Contract #: 04-0120F4
 Cty: SF/ALA Rte: 80 PM: 13.2/13.9
 File #: 69.25B

QUALITY ASSURANCE -- NON-CONFORMANCE REPORT

Location: Changxing Island, Shanghai, P.R. China **Report No:** NCR-000795
Prime Contractor: American Bridge/Fluor Enterprises, a JV **Date:** 12-Jul-2010
Submitting Contractor: Zhenhua Port Machinery Company, Ltd (ZPMC), Changxing Island **NCR #:** ZPMC-0757

Reference Description: A Light Mounting Bracket on a 9DW Counterweight was damaged and bent

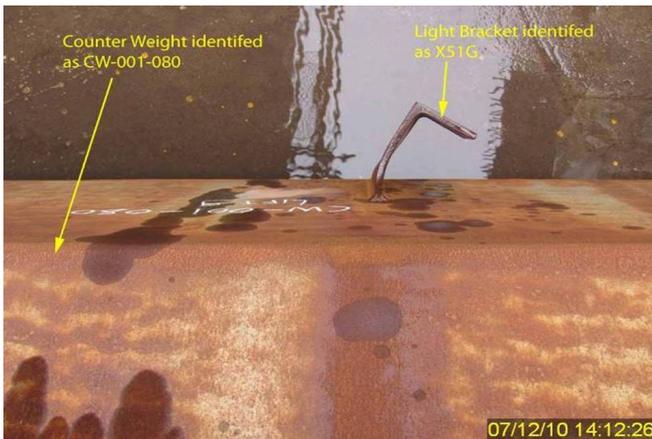
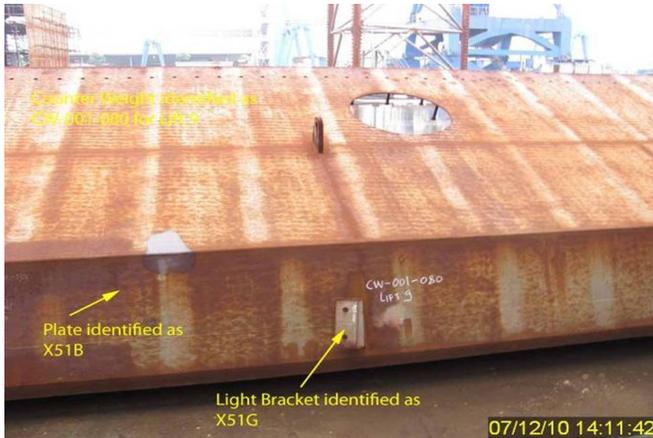
- The Counterweight Light Mounting Bracket was damaged and bent.
- The maximum displacement of the Light Mounting Bracket is 80mm.
- Counterweight of concern is CW-001-080 (Segment 9DW).
- Light Mounting Bracket identified as X51G.
- Counterweight Plate identified as X51B to which Light Mounting Bracket is welded.
- Counterweight CW-001-080 is located in the outside yard, behind bay 13.
- The area has previously tested and accepted by ZPMC prior to this damage.

Standard Specifications July, 1999 Section 55-1.04 Shipping, Handling and Storing Materials; "In handling and shipping of the steel work, every care shall be taken to avoid bending, scraping or overstressing the pieces. All pieces bent or otherwise injured will be rejected.

Reference Resolution: ZPMC is providing the heat straightening record used when they performed the work and the NDT done after to show the affected weld is acceptable.

The proposed resolution is acceptable for the heat straightening without the Engineer's approval. However, the issue of improper storage and handling which the NCR was issued for, still needs to be addressed.

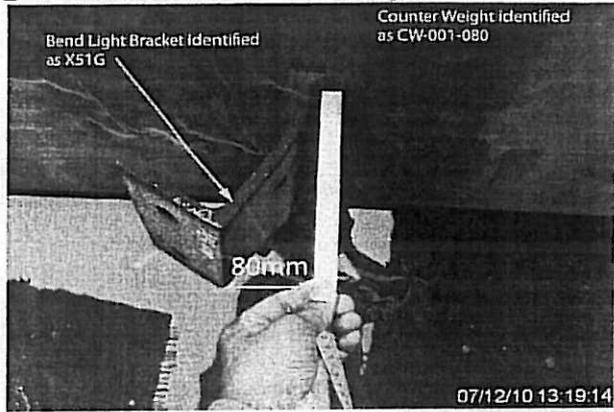
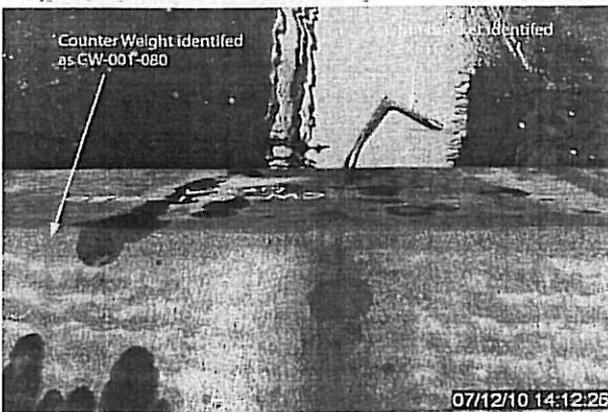
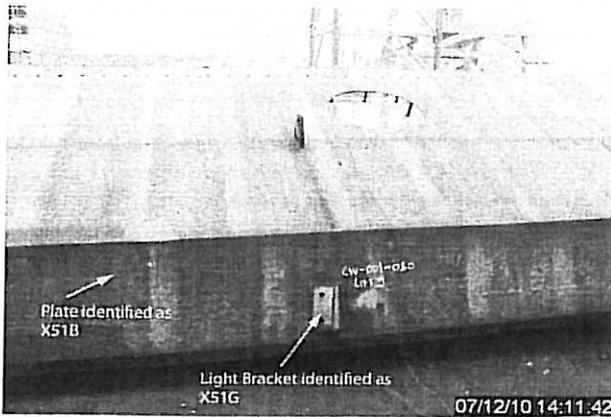
- The Counterweight Light Mounting Bracket was damaged and bent.
- The maximum displacement of the Light Mounting Bracket is 80mm.
- Counterweight of concern is CW-001-080 (Segment 9DW).
- Light Mounting Bracket identified as X51G.
- Counterweight Plate identified as X51B to which Light Mounting Bracket is welded.
- Counterweight CW-001-080 is located in the outside yard, behind bay 13.
- The area has previously tested and accepted by ZPMC prior to this damage.

Standard Specifications July, 1999 Section 55-1.04 Shipping, Handling and Storing Materials; "In handling and shipping of the steel work, every care shall be taken to avoid bending, scraping or overstressing the pieces. All pieces bent or otherwise injured will be rejected.

<h2 style="margin: 0;">火工校正记录</h2> <h3 style="margin: 0;">Heat Straightening Record (HSR1)</h3>	报告号 Record #	HSR1(B)-8655 -
	版本号 Revision #	0
日期 Date		2010.08.17

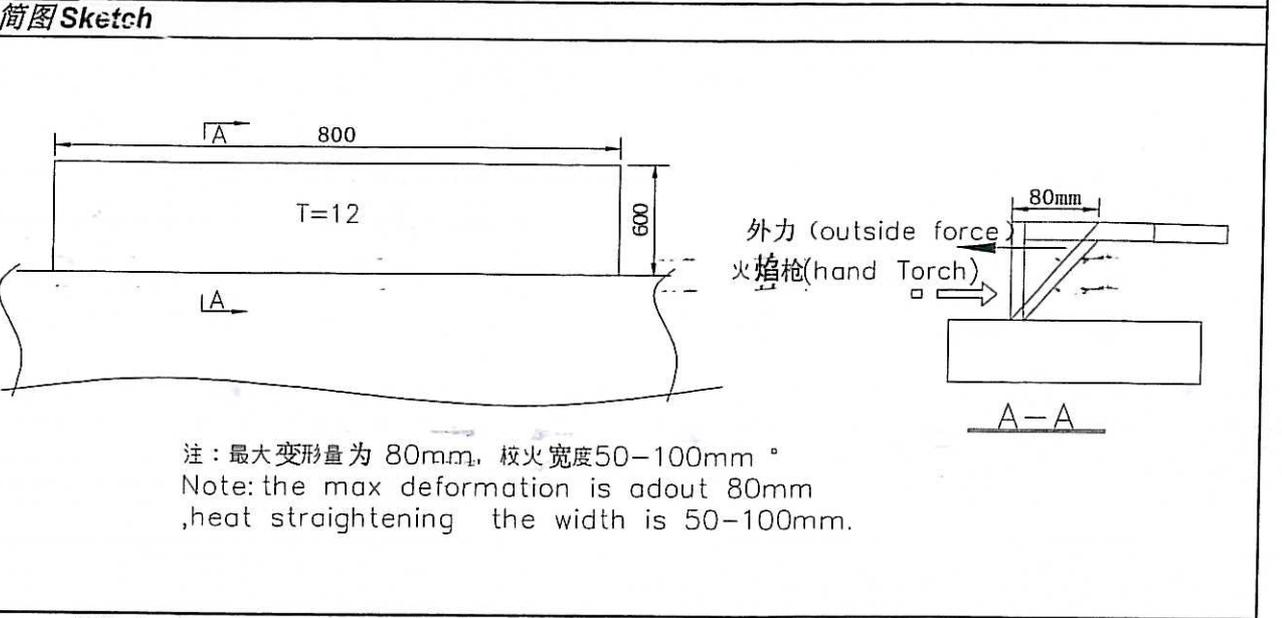
情况描述 Description of Condition	
Cause 原因	Welding distortion 焊接变形
Type of Defect 缺陷类型	Welding distortion 焊接变形
Inspection Method 检查方法	Visual 目检

缺陷去除方法(Defect Removal Method): 1、Flame Straightening by oxygen acetylene 运用氧乙炔进行校火 2、QC is responsible for monitoring temperature during heat straightening. QC必须持有校火报告批准件, 全程监控, 并控制好校火温度。

后续NDE(Post-Removal NDE): Jack shall be used in a manner such that all forces are applied passively. After finishing heat straightening, the weld of the heated area shall perform NDT according to approved shop drawing. 正确使用千斤顶, 避免因千斤顶使用不当造成构件塑性变形; 校火后, 根据图纸要求对校火区和热影响区域进行100%VT, 100%MT, 检测。

纠正措施(Corrective Action(s)): Fasten subcomponent to transportation trailer securely prior to transport. 转运之前将构件安全地紧固在转运拖车上。

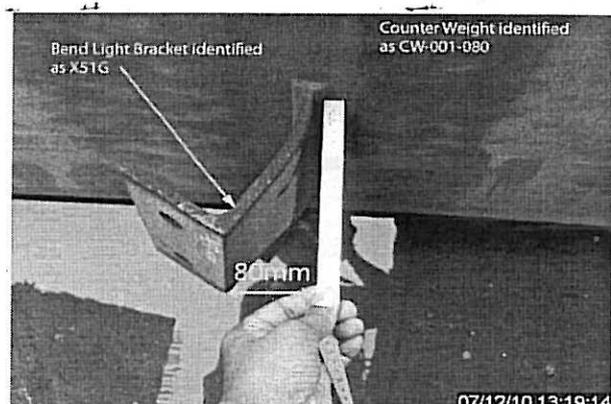
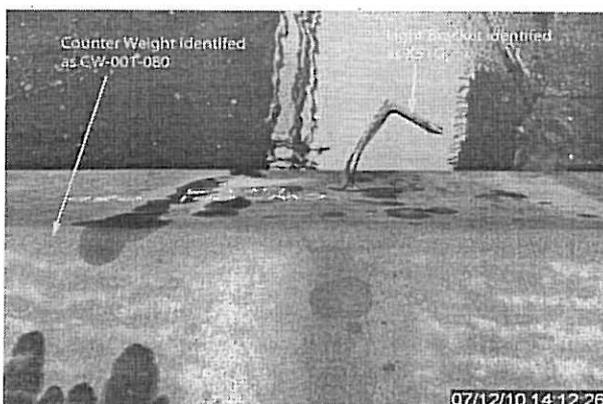
- The Counterweight Light Mounting Bracket was damaged and bent.
- The maximum displacement of the Light Mounting Bracket is 80mm.
- Counterweight of concern is CW-001-080 (Segment 9DW).
- Light Mounting Bracket identified as X51G.
- Counterweight Plate identified as X51B to which Light Mounting Bracket is welded.
- Counterweight CW-001-080 is located in the outside yard, behind bay 13.
- The area has previously tested and accepted by ZPMC prior to this damage.

Standard Specifications July, 1999 Section 55-1.04 Shipping, Handling and Storing Materials; "In handling and shipping of the steel work, every care shall be taken to avoid bending, scraping or overstressing the pieces. All pieces bent or otherwise injured will be rejected.
